**LEBANON PLANNING BOARD
OCTOBER 12, 2021 - 6:30 PM
COUNCIL CHAMBERS, CITY HALL OR
REMOTE VIA VIRTUAL PLATFORM
LEBANONNH.GOV/LIVE**

**Mason Storage, LLC,
38 Spencer Street
(Tax Map 78, Lot 39),
Zoned LD
PB2021-13-SPR**

Staff Memorandum – PB2021-13-SPR – *continued from 9/13/21*

Re: Site Plan Lot 78-39
38 Spencer Street

Conclusions

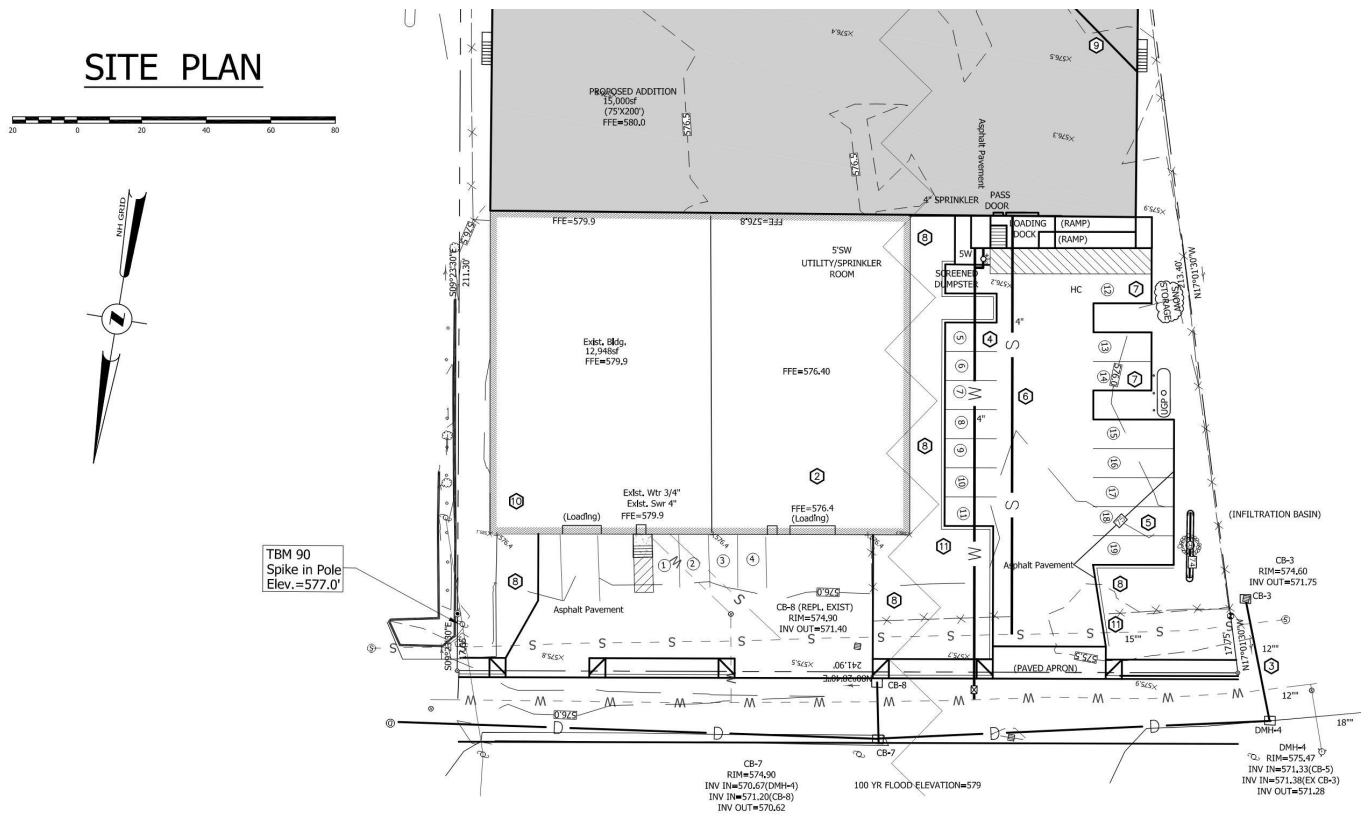
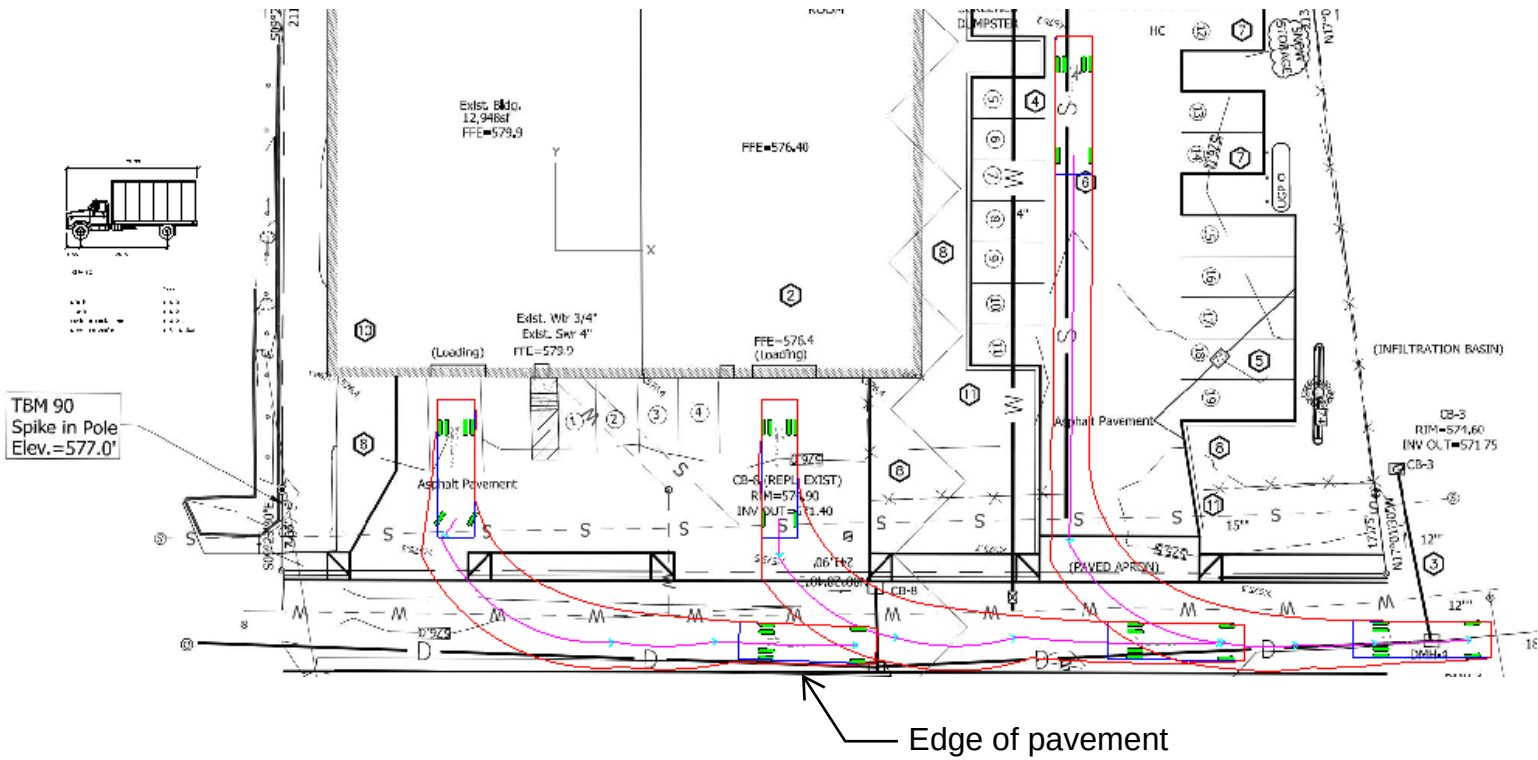
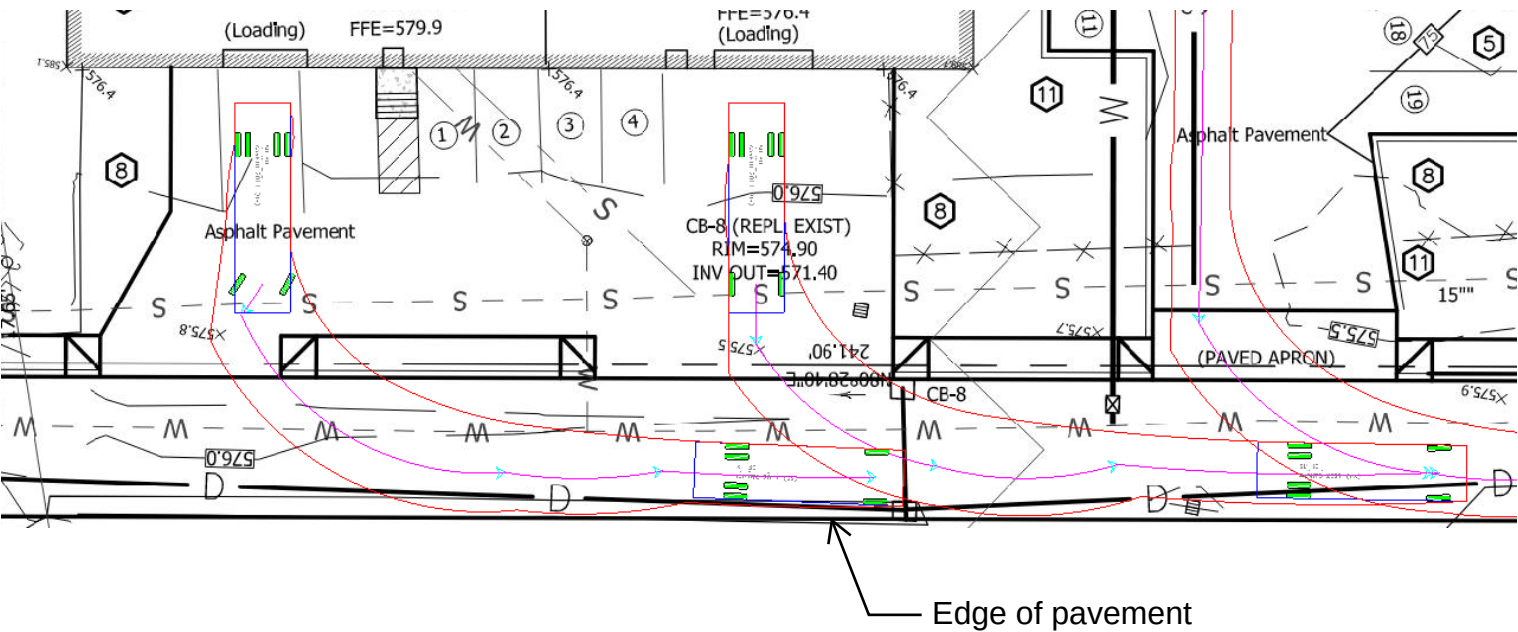
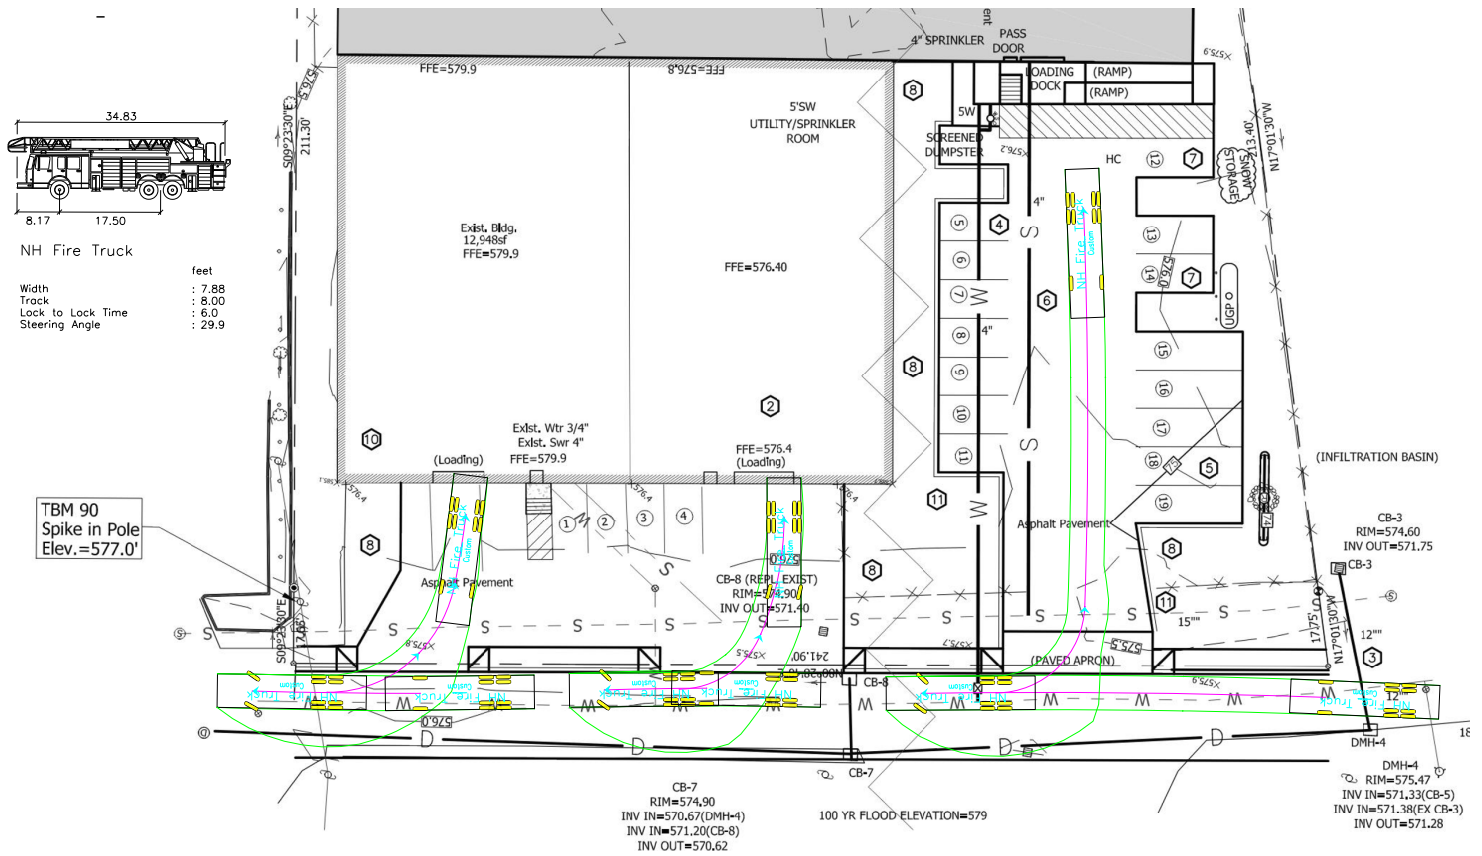
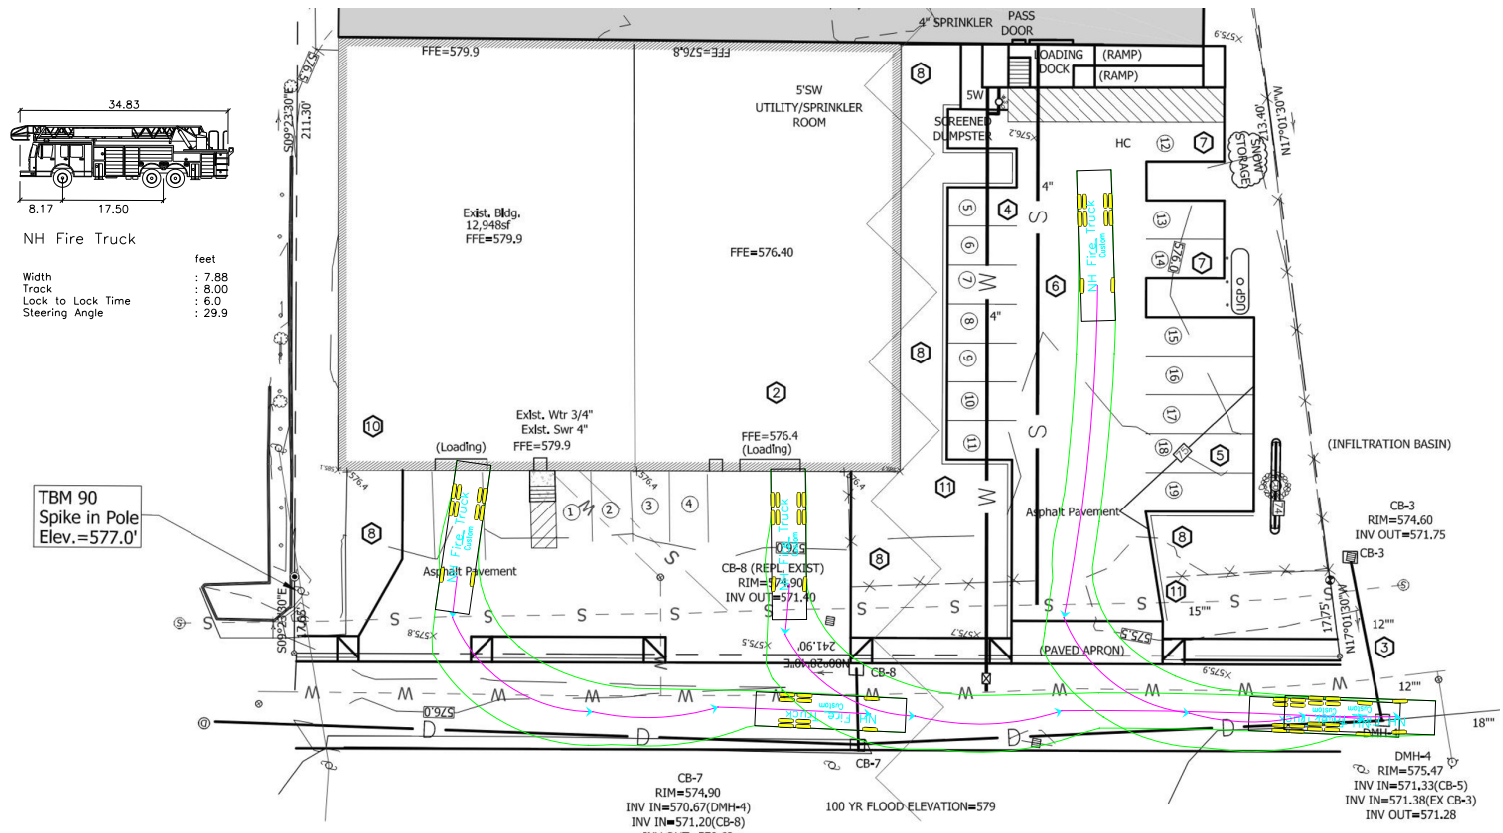
WCG recommends the sidewalk and curb islands through the drives are mountable curbs, and the concrete sidewalks should be 8" thick to withstand vehicle loading. We further recommend that parking is restricted along the sidewalk and curbed islands in front of the parking and loading areas through the illustrated vehicle paths.

Attachment 1 Sheet C-1, site plan.

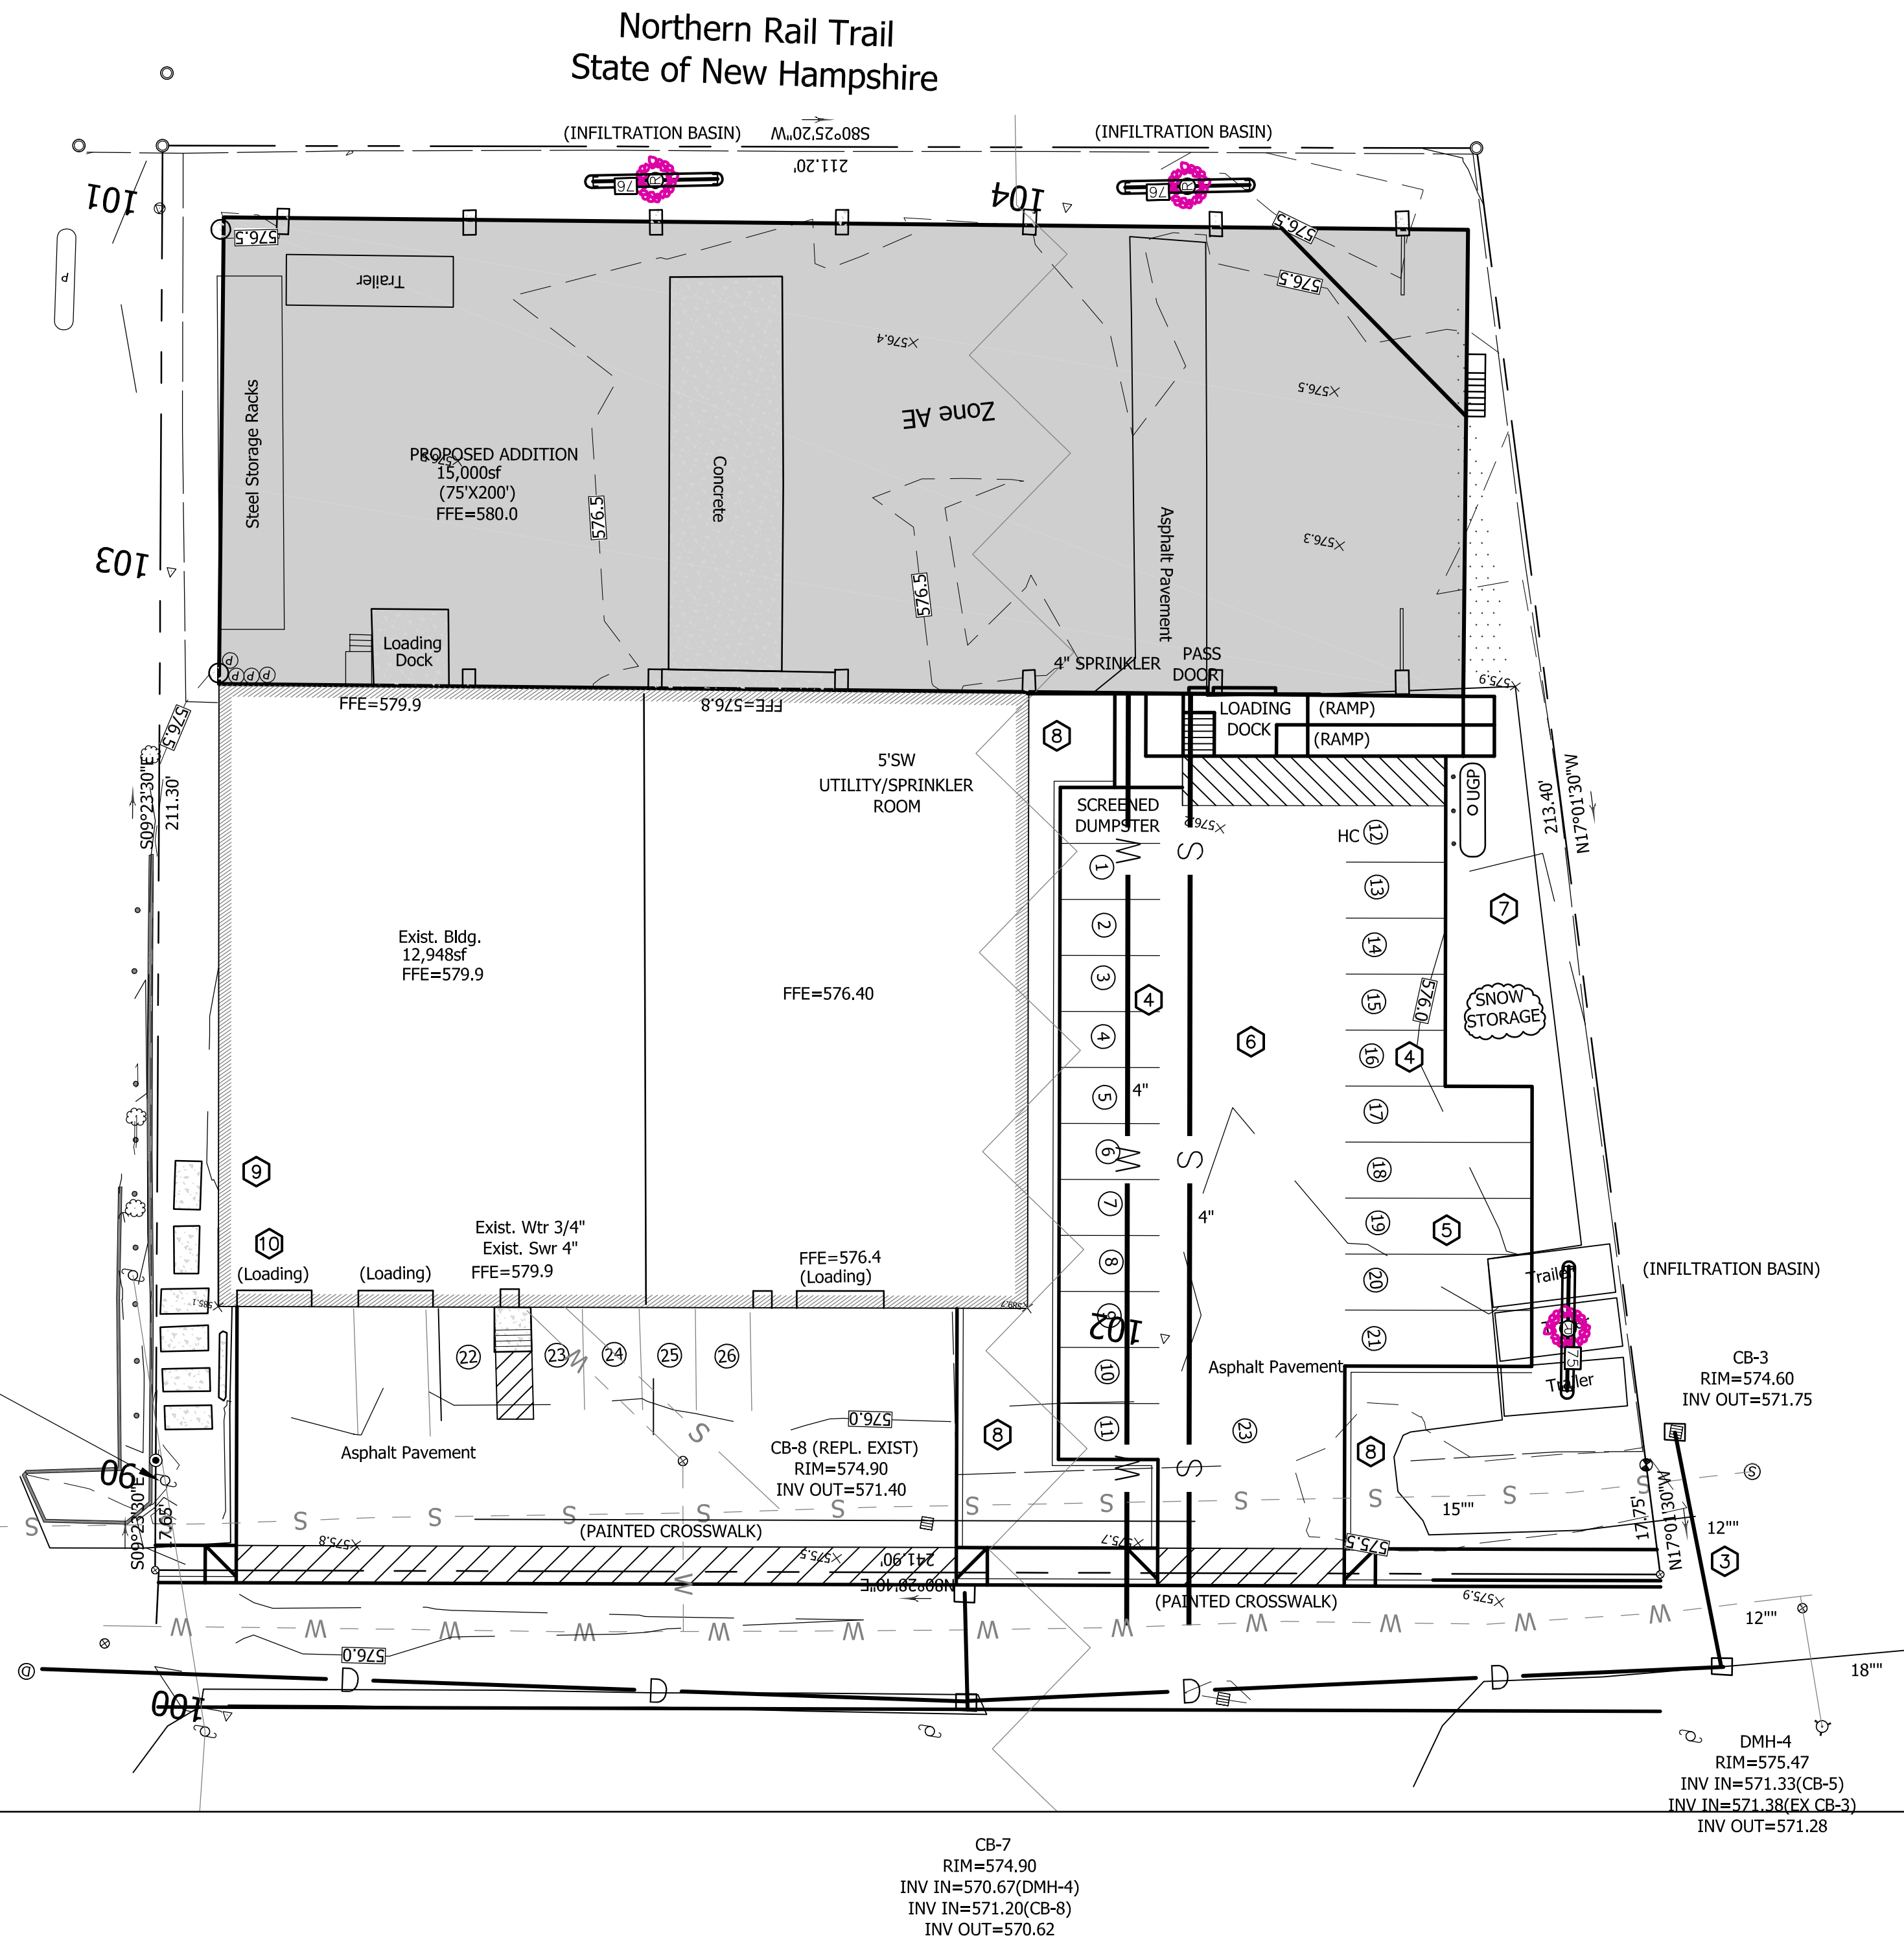
Section 6.5.B.6. An entry walk exists at the front of the building. It is now shown as a striped walk on Sheet C-1. Therefore, a waiver should not be needed.

- i. Dimensions are indicated in Notes on Sheet C-1.
- ii. Snow storage has been moved.
